|  | Residue Upgradation Facility (RUF) EPCC-3 Package for Visakh Refinery Modernization Project (VRMP) |  L&T Hydrocarbon Engineering |
| Title: Process Datasheet for CLOSED BLOWDOWN DRUM 1 (504-V-803) Doc. No.: B016-RUF-LT-504-PC-DS-0284 | | Rev. No.: 0 Page No: 1 of 2 |

ANNEXURE – 1**CHANGE LIST**

EQUIPMENT NUMBER: 504-V-803
 EQUIPMENT NAME: CLOSED BLOWDOWN DRUM I
 PROCESS DATA

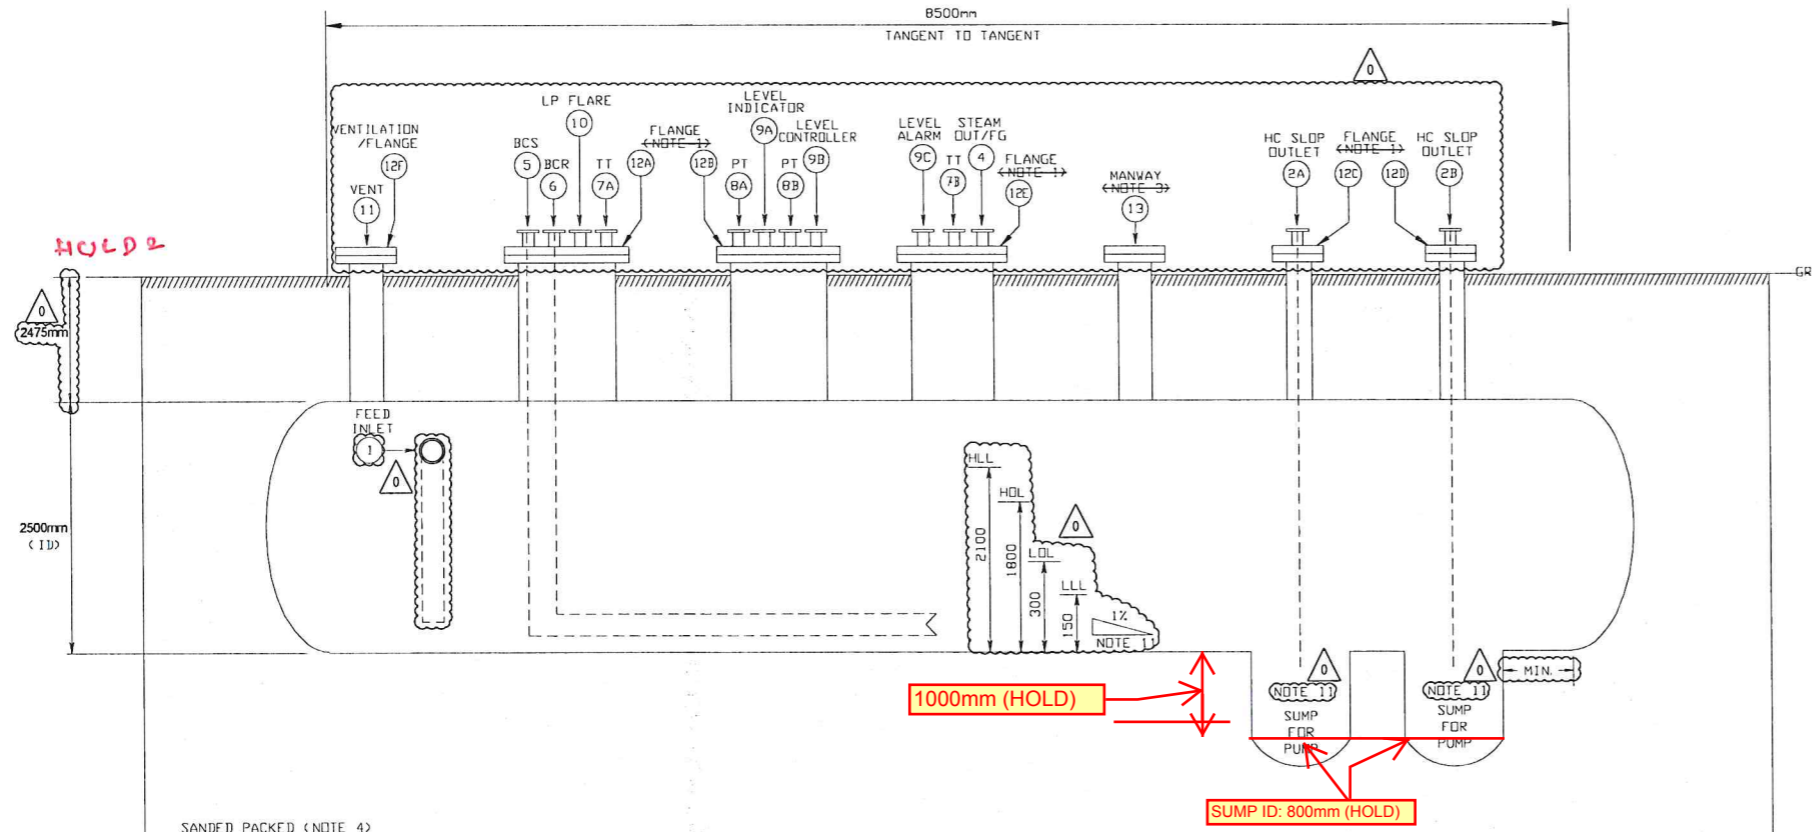
| Sr. No. | Page No. | Description of change | Reference / Remarks |
|---------|----------|---|---|
| 1. | 2 | Flanges numbers revised & sizes are defined in nozzle details & corresponding Note 1 is updated. | As per flange design input by Mechanical department. For detail refer mechanical engineering drawing. Number of flanges and detail will be updated in Rev 1 of P&ID: B016-RUF-LT-PID-504-11812. |
| 2. | 2 | Vent (#11) & steam out nozzles (#4) sizes are confirmed as 2” each as vessel is non-cladded, in nozzle details & corresponding Note 2 is updated. | As per EIL guidelines in BEDB (Part-B) clause 8.5.3.3 doc. no.: A758-999-02-41-ODB-1001 pg. 73 of 115. |
| 3. | 2 | Manway nozzle (#13) size (24”) and location is confirmed and Note 3 deleted accordingly. | 1. Location is at top shell of horizontal vessel. Final location will be decided by Mechanical engineering based on piping. There is no other Process engineering input required. 2. Manway size is based on EIL BEDB (Part-B) clause 8.5.3.3 A758-999-02-41-ODB-1001 pg. 73 of 115. |
| 4. | 2 | Drum location w.r.t ground level is defined on vessel sketch and corresponding Note 4 is modified. | Relative elevation of drum is provided as per piping input considering slope of feed inlet header to the vessel. |
| 5. | 2 | Nozzle numbering is added to nozzle details and on vessel sketch. | For better clarity on nozzle identification. |

| Sr. No. | Page No. | Description of change | Reference / Remarks |
|---------|----------|---|---|
| 6. | 2 | Feed nozzle (#1) size changed from 6" to 10" and update the nozzle location. | As per clause C-123 of Annexure A of "C-1.3B016-79-41-EPC-107 Rev-4" page 61 of 66 and consistent with P&ID: B016-RUF-LT-PID-504-11812 (Rev 0). The feed nozzle was fouling with knuckle of vessels while placing it above HLL. Hence, the feed nozzle was shifted to shell as marked based on input by Mechanical department. |
| 7. | 2 | Ventilation/Vent nozzle (#12F) updated to Ventilation/Flange nozzle and Vent nozzle #11 defined separately. | As per mechanical department input, Ventilation nozzle is considered as flange. For further details, please refer Mechanical Engineering Drawing. |
| 8. | 2 | Cooling water supply and cooling water return word is changed to Bearing cooling water supply (#5) and Bearing cooling water return (#6) respectively in nozzle detail table. Also corresponding changes made in sketch and note 5 i.e. CWS and CWR changed to BCS and BCR. | To keep it in-line with P&ID: B016-RUF-LT-PID-504-11812 (Rev 0). |
| 9. | 2 | Level taps nozzle (#9) sizes are defined as 4". | As per Instrument design basis & EIL guidelines in doc. no. B016-504-16-EDB-95097-52-0001. |
| 10. | 2 | Liquid level nomenclature is modified on vessel sketch for better clarity on level identification. | As per EIL guidelines in BEDB (Part-B) Abbreviations on pg. 11 of 115 A758-999-02-41-ODB-1001. |
| 11. | 2 | High Liquid Level (HLL) is revised from 2200mm to 2100mm. Low liquid level (LLL) is defined as 150 mm. | To place the Feed nozzle above HLL, the HLL was reduced. The total pumpable volume between HLL and LLL is ensured as 40 m ³ as specified in EIL BEDB (Part-B) clause 6.8.2 pg. 44 of 115 A758-999-02-41-ODB-1001. For detail calculations, please refer Annexure 2. |

| Sr. No. | Page No. | Description of change | Reference / Remarks |
|---------|----------|---|--|
| 12. | 2 | Slope is defined as 1% inside vessel and corresponding Note 11 is added. | To drain towards sumps as per good engineering practice. It will be updated in Rev 1 of P&ID: B016-RUF-LT-PID-504-11812. |
| 13. | 2 | Sump and pump discharge nozzle location is changed in vessel sketch and corresponding Note 11 is added. | Location of sumps is towards sloping end of vessel and minimum from TL. Location is changed in order to ensure complete draining of vessel due to slope. |
| 14. | 2 | Trim added as Note 9. | As per PMS of inlet and outlet lines indicated in P&ID: B016-RUF-LT-PID-504-11812 (Rev 0). |
| 15. | 2 | MDMT added in Note 9. | As per EIL guidelines in BEDB (Part-B) clause 4.2 pg. 22 of 115 A758-999-02-41-ODB-1001. |
